SERVICE BULLETIN

FUSELAGE - TAIL BOOM

Patches on the EC130 Fenestron / tail cone link

Corresponds to modification 074775

Figure 1

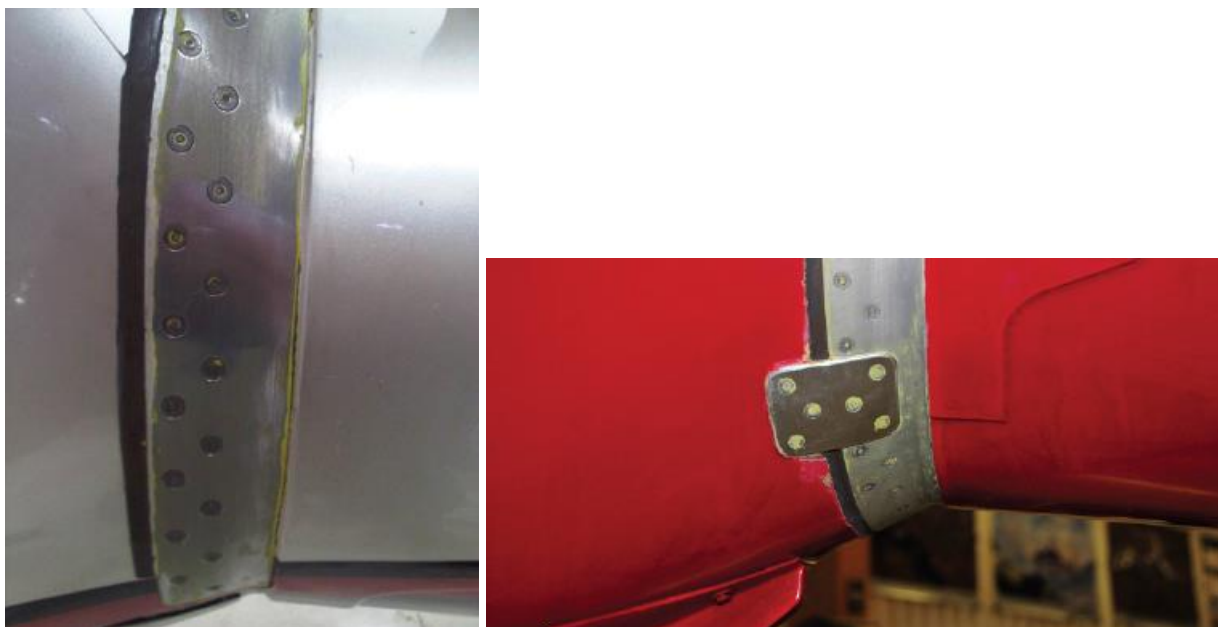
- Strip both rivet rows on the periphery of the junction, on the Fenestron side up to the tail boom skin, as per [Figure 1](#).
- Perform a dye penetrant inspection of the zone using dye penetrant inspection aerosol (50), (51) or (59) and (52) as per Work Card 20-02-09-101 (MTC) and 20-02-09-601 (MTC) or an inspection by Eddy current as per Work Card 20-90-03-108 (MTC).

Figure 3 (Helicopters PRE MOD 073880)

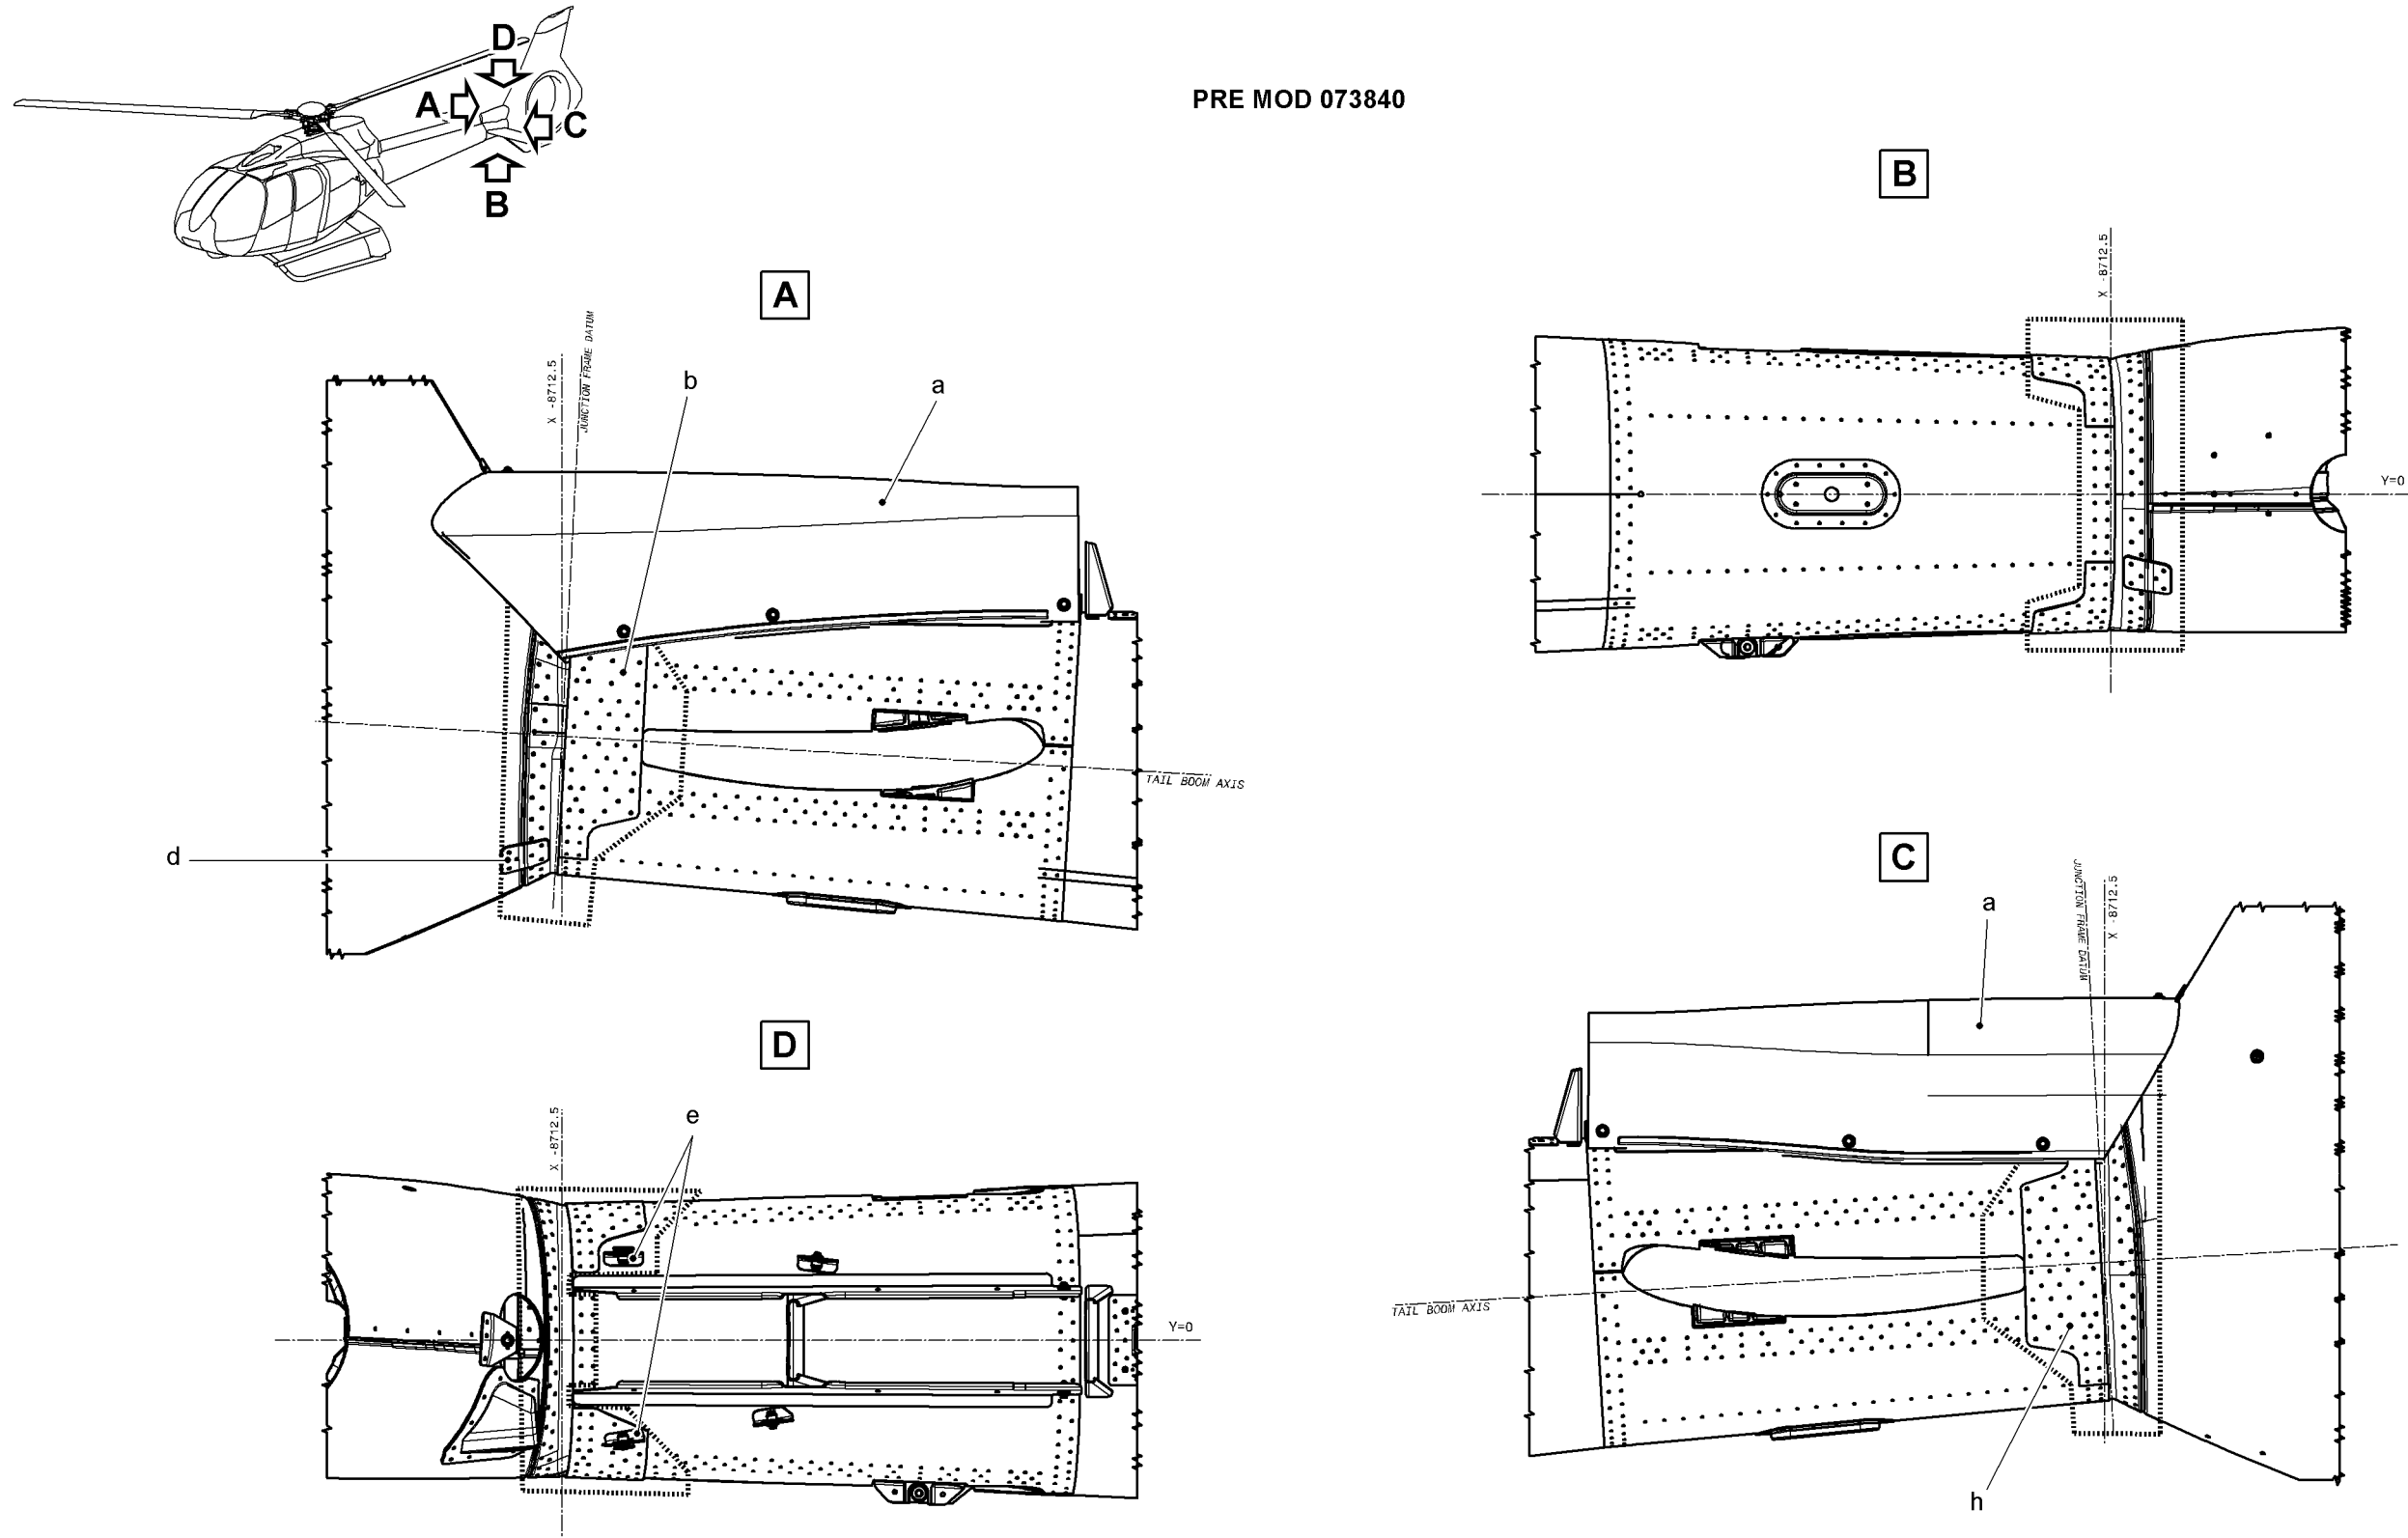
- Sand the paint of splice (b) or (c) and bonding plate (d) to reveal the rivet heads ([Figure 3](#) or [Figure 4](#)).
- Remove and discard splice (b) or (c), bonding plate (d) and attachment bracket (e).
- Position and mark patch (1) on the structure with a marker (Figure 5).

- Sand splice (h) or (j) to reveal the rivet heads ([Figure 3](#) or [Figure 4](#)).
- Remove and discard splice (h) or (j) and attachment bracket (e).
- Position and mark patch (34) on the structure ([Figure 10](#)).
- Remove patch (34).
- Sand and strip the area of application of patch (34) until the rivets appear.
- Discard the rivets.
- Cut out the hatched area with cut-out template (bb) ([Figure 6](#) - Detail B).
- Deburr and sand sharp edges with sandpaper (zzz).
- Position and hold patch (34).

Figure 5

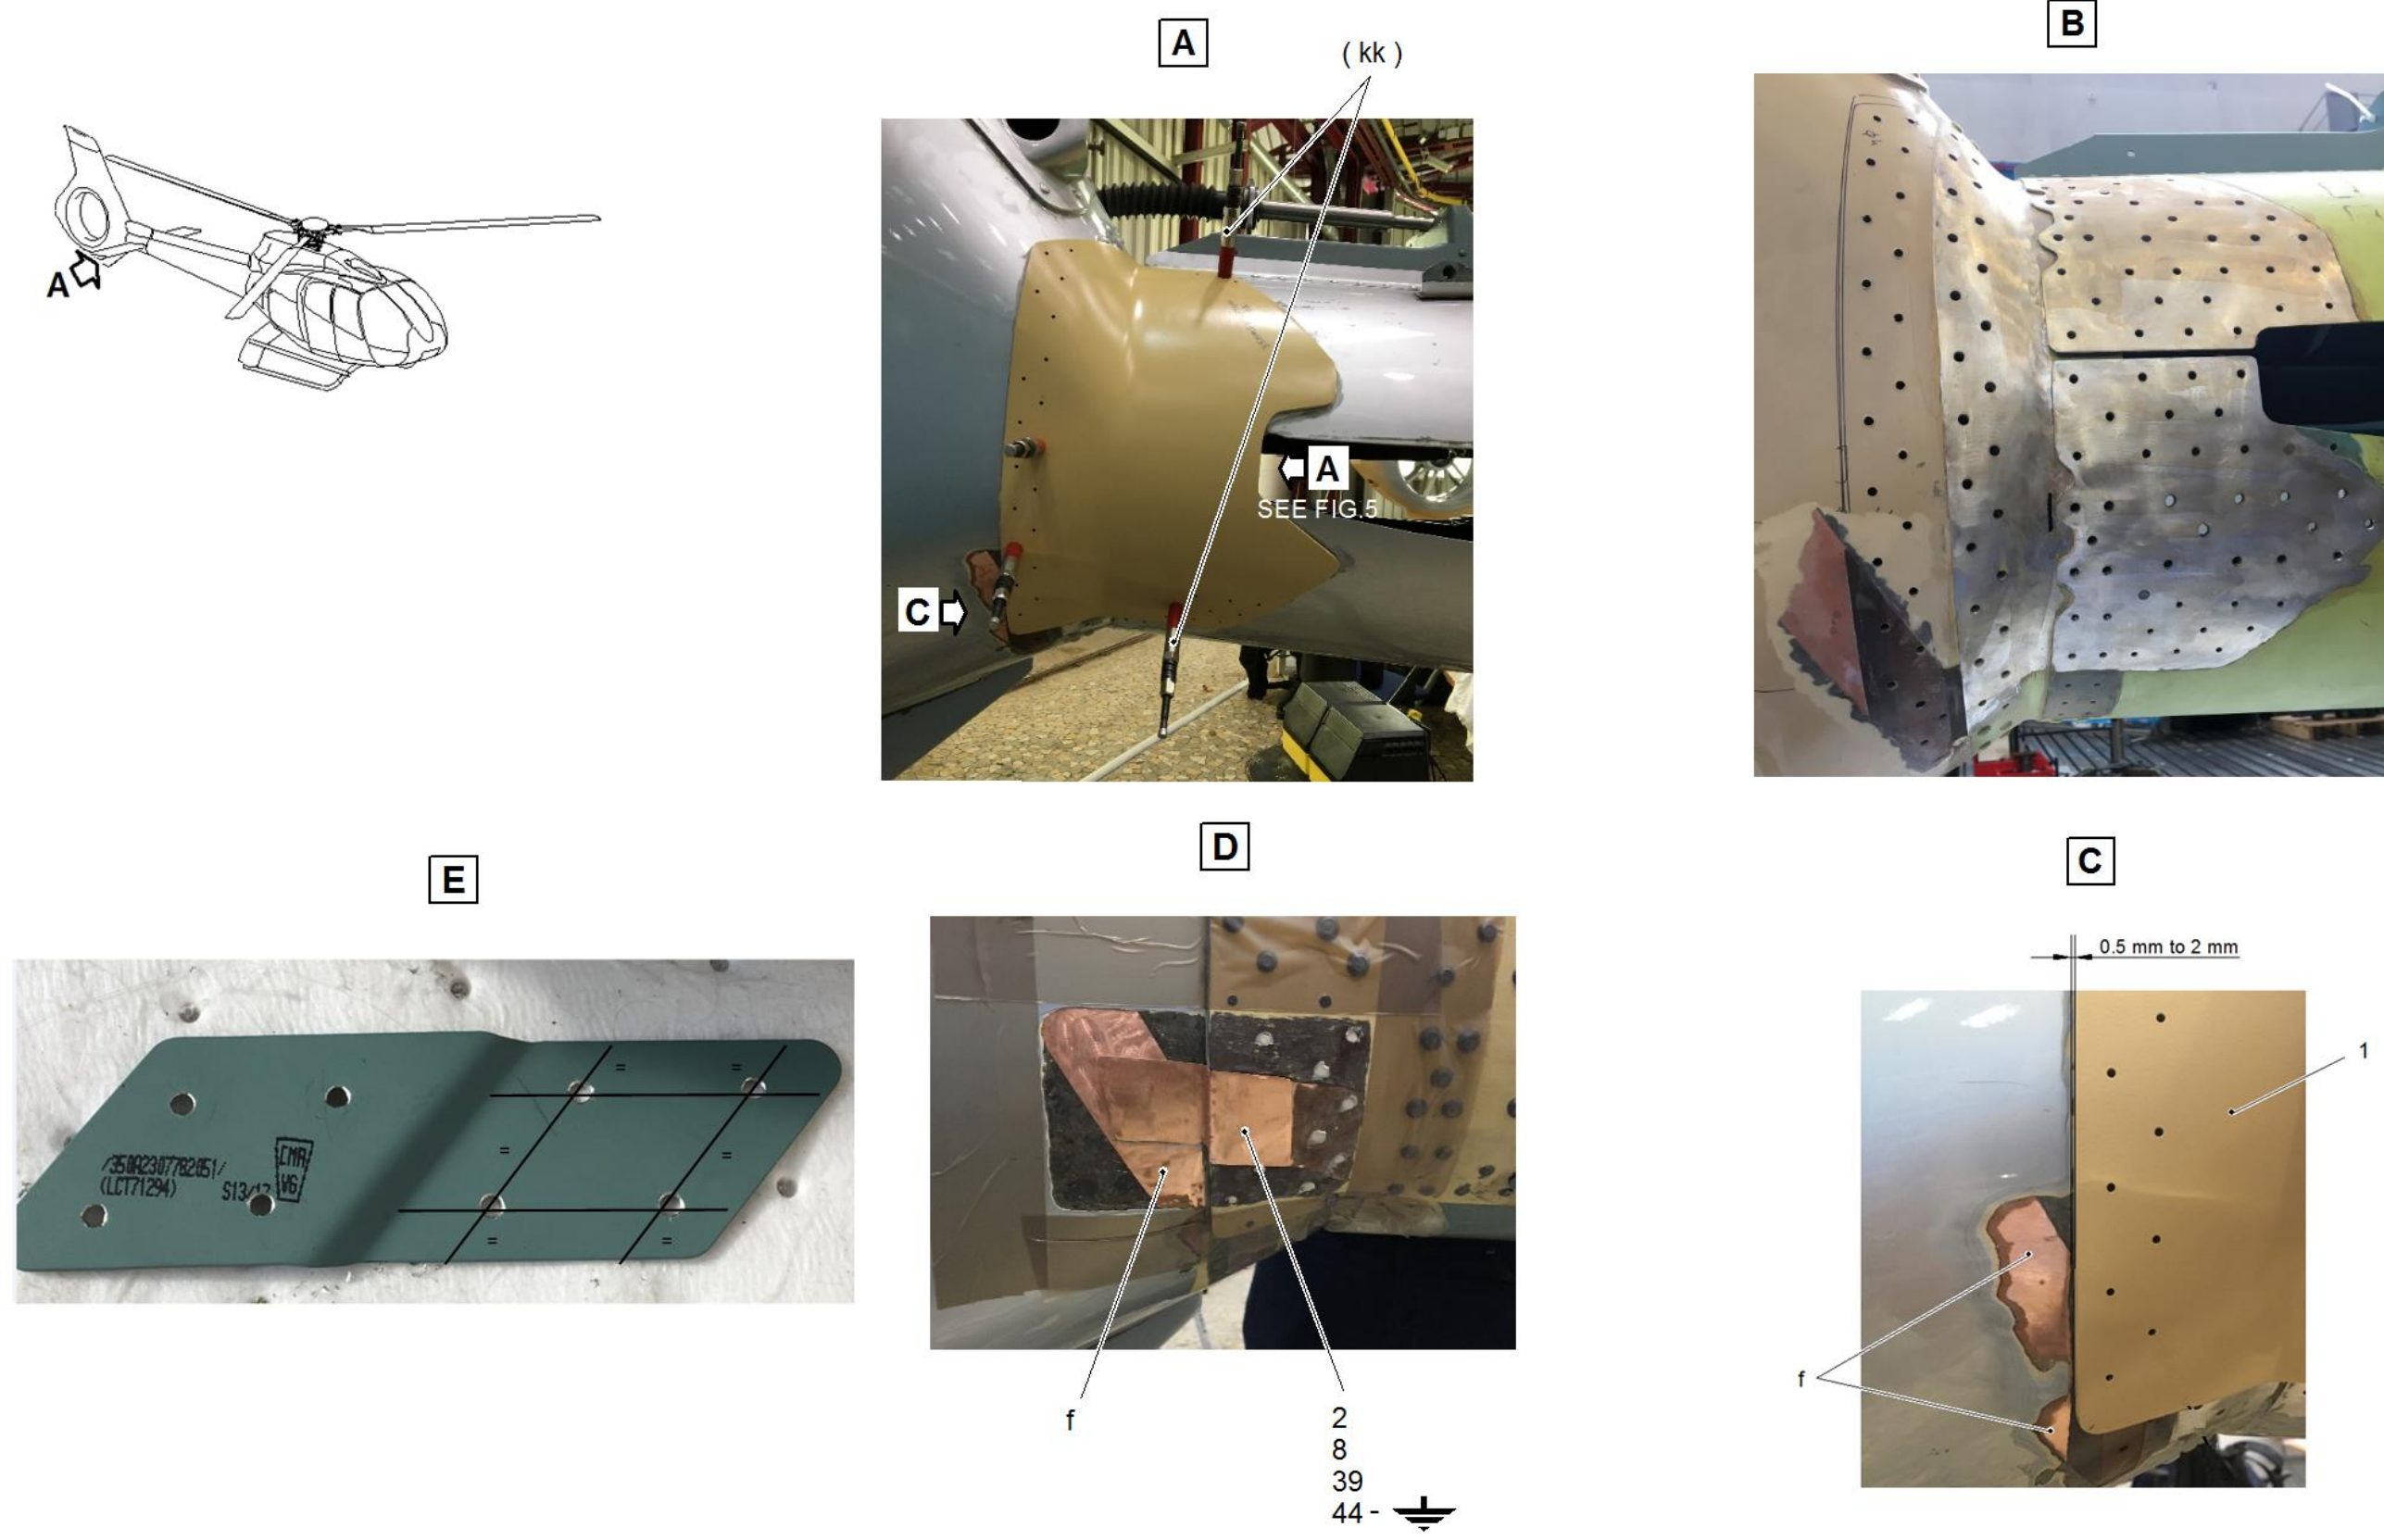
- Remove patch (1).
- Sand and strip the (metal) area of application of patch (1) until the rivets and copper strip (f) appear ([Figure 5](#) - Detail B).

- Discard the rivets.
- Identify and sand the area of application of foil (2) and splices (3) or (4) or (5) on the structure as per Figures 8 and 9.
- Cut and discard copper strip (f) in contact with patch (1) ([Figure 5](#) - Details B and C).

- Predrill the existing holes of patch (1) in the structure with \varnothing 2.5 drill (zz) ([Figure 5](#) - Details A and C).
- Temporarily attach patch (1) with \varnothing 2.5 spring fasteners (kk) ([Figure 5](#) - Detail A).
- Jig-bore patch (1) from inside the tail boom, in accordance with the holes in the structure, using drill \varnothing 3.1 (yy) or \varnothing 4 (xx) or \varnothing 4.8 (ww).
- Remove patch (1).

Figure 6 (Skin cut-out on the RH and LH sides)

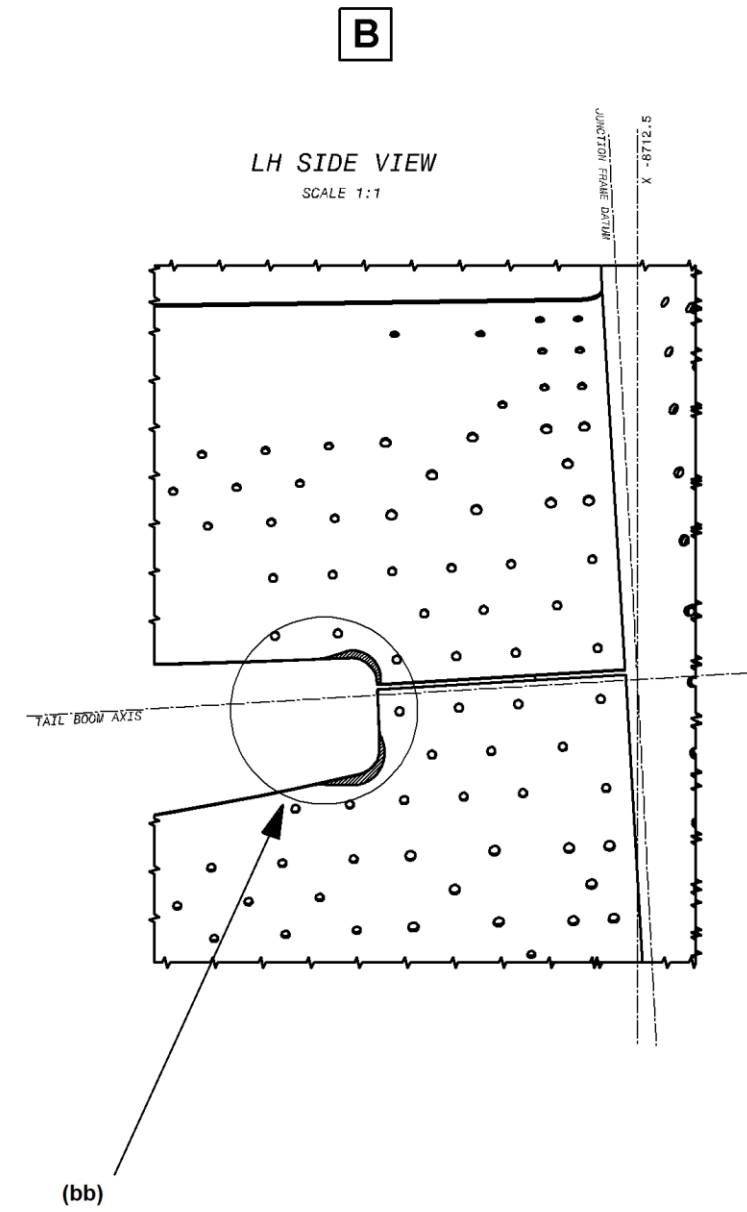
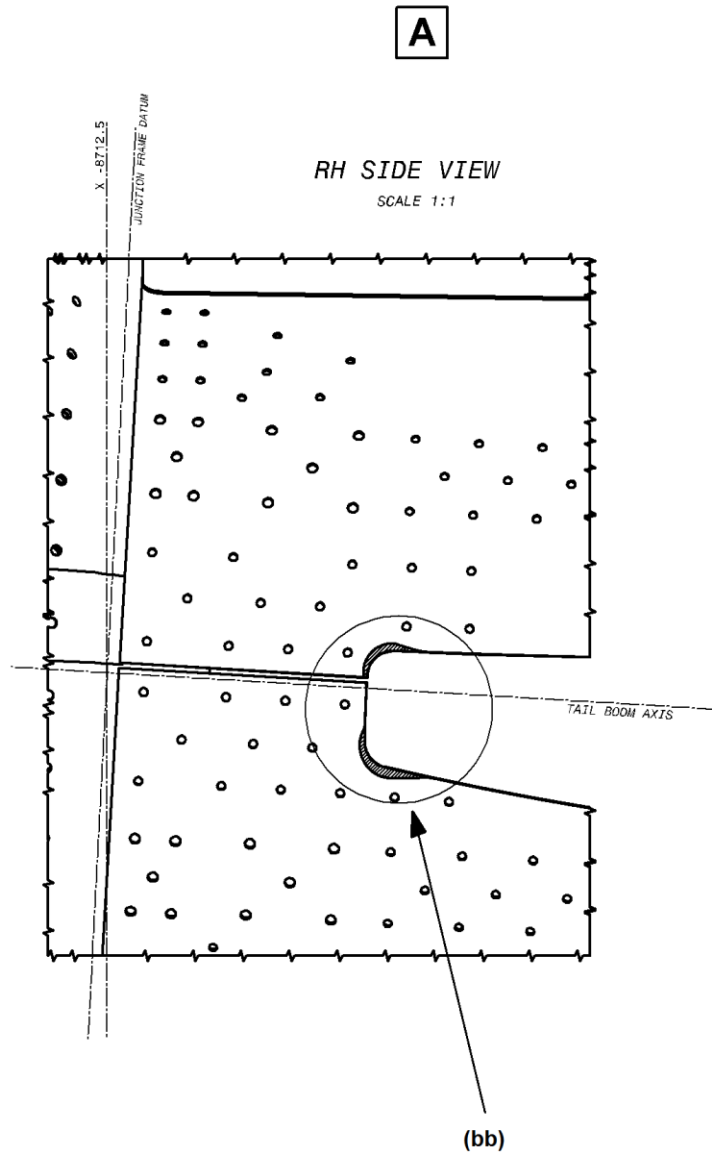
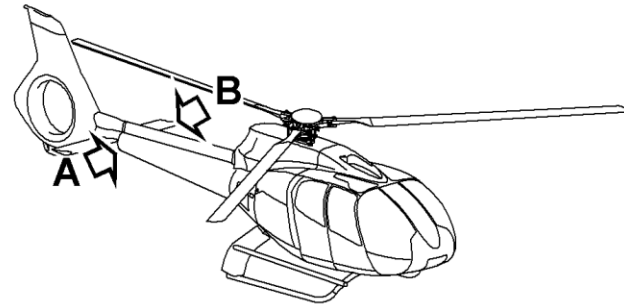
- Cut out the hatched area with cut-out template (jj) ([Figure 6](#) - Detail A).
- Deburr and sand sharp edges with sandpaper (zzz).
- Position and hold patch (1).
